# RESPONSE TO SUBMISSIONS AND PRELIMINARY ASSESSMENT

SCEGGS DARLINGHURST CONCEPT PLAN  
AND WILKINSON HOUSE REDEVELOPMENT

SA7240  
FINAL  
PREPARED FOR SCEGGS DARLINGHURST

Figure 18 – Shadow Diagram – Thomson Street and Thomson Lane Detail

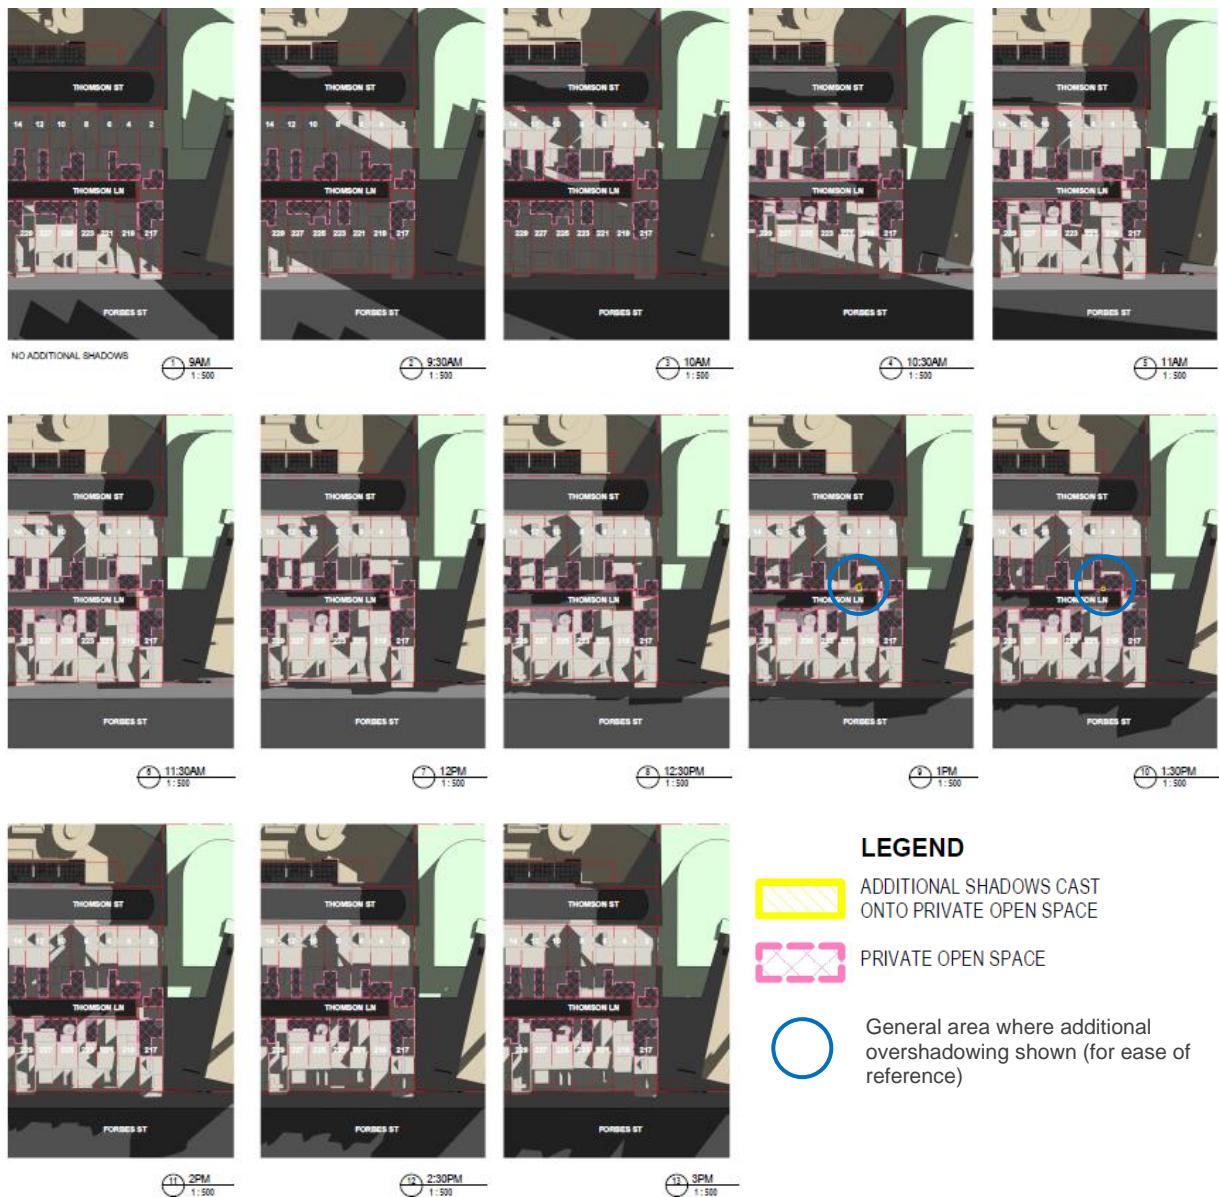
- The amended design casts additional shadows into the rear private open space of 4 Thomson Street only at 1:00pm and 1:30pm. The additional overshadowing is of minimal impact to a small corner of the rear yard, and results in a minimal loss of solar access compared to existing (**Figure 18**).

- The amended design does not cause any other additional overshadowing impacts to the private open spaces of Thomson Street and Thomson Lane terraces compared to the existing buildings (**Figure 18**).

- The amended design casts minor amounts of additional shadows on the western façade of Thomson Street terraces from 11:30am to 3:00pm as shown at **Figure 19**. Compared with the existing shadow impacts, the amended design reduces the amount of shadows cast from 12:00pm to 3:00pm.

Figure 26 – Overland Flow Path from Thomson Street to Bourke Street

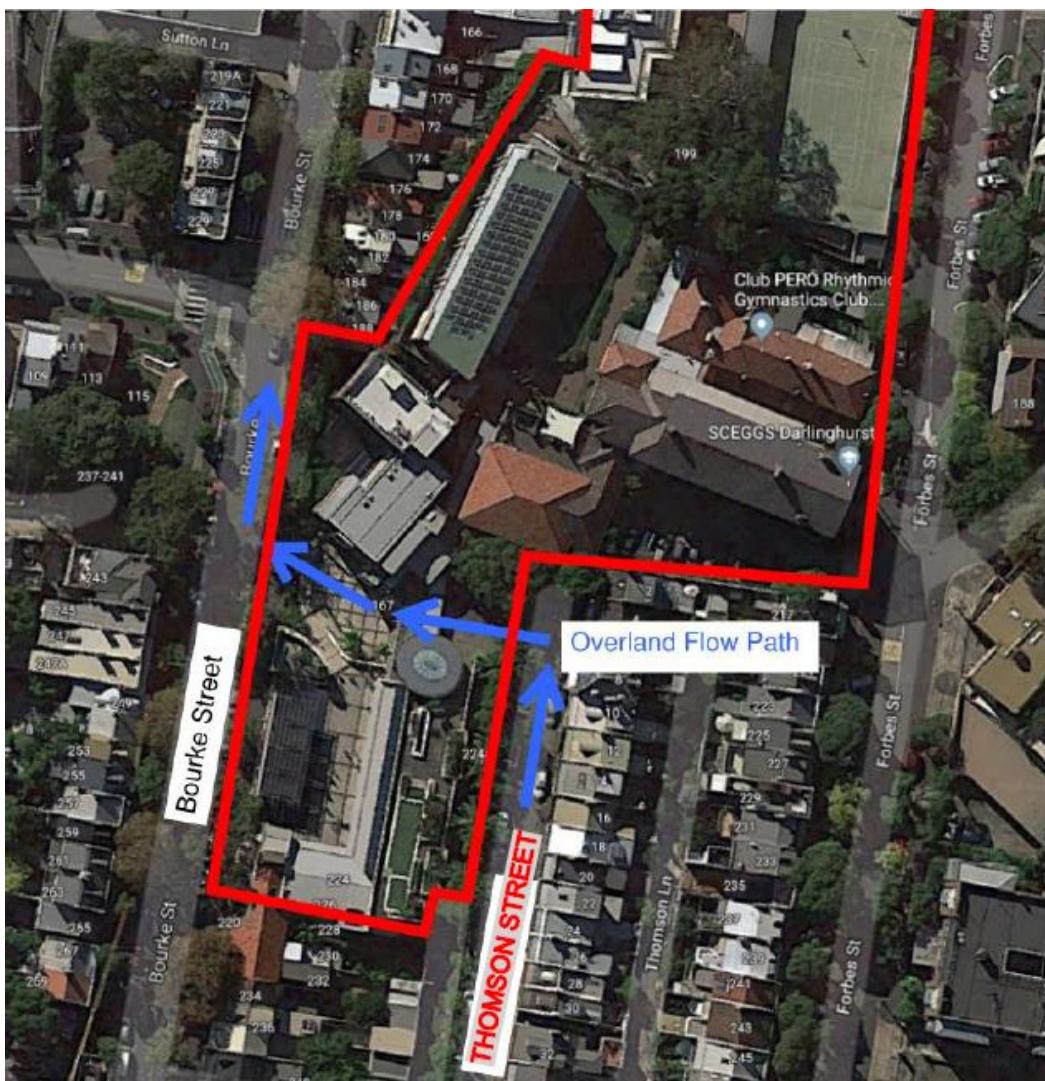
Thomson Street is a low point and floodwaters will pond here and may spill over the retaining wall and into the SCEGGS Darlinghurst property. If the floodwaters spill over the retaining wall, an overland flow path exists through the SCEGGS Darlinghurst property towards Bourke Street as shown in **Figure 26**.
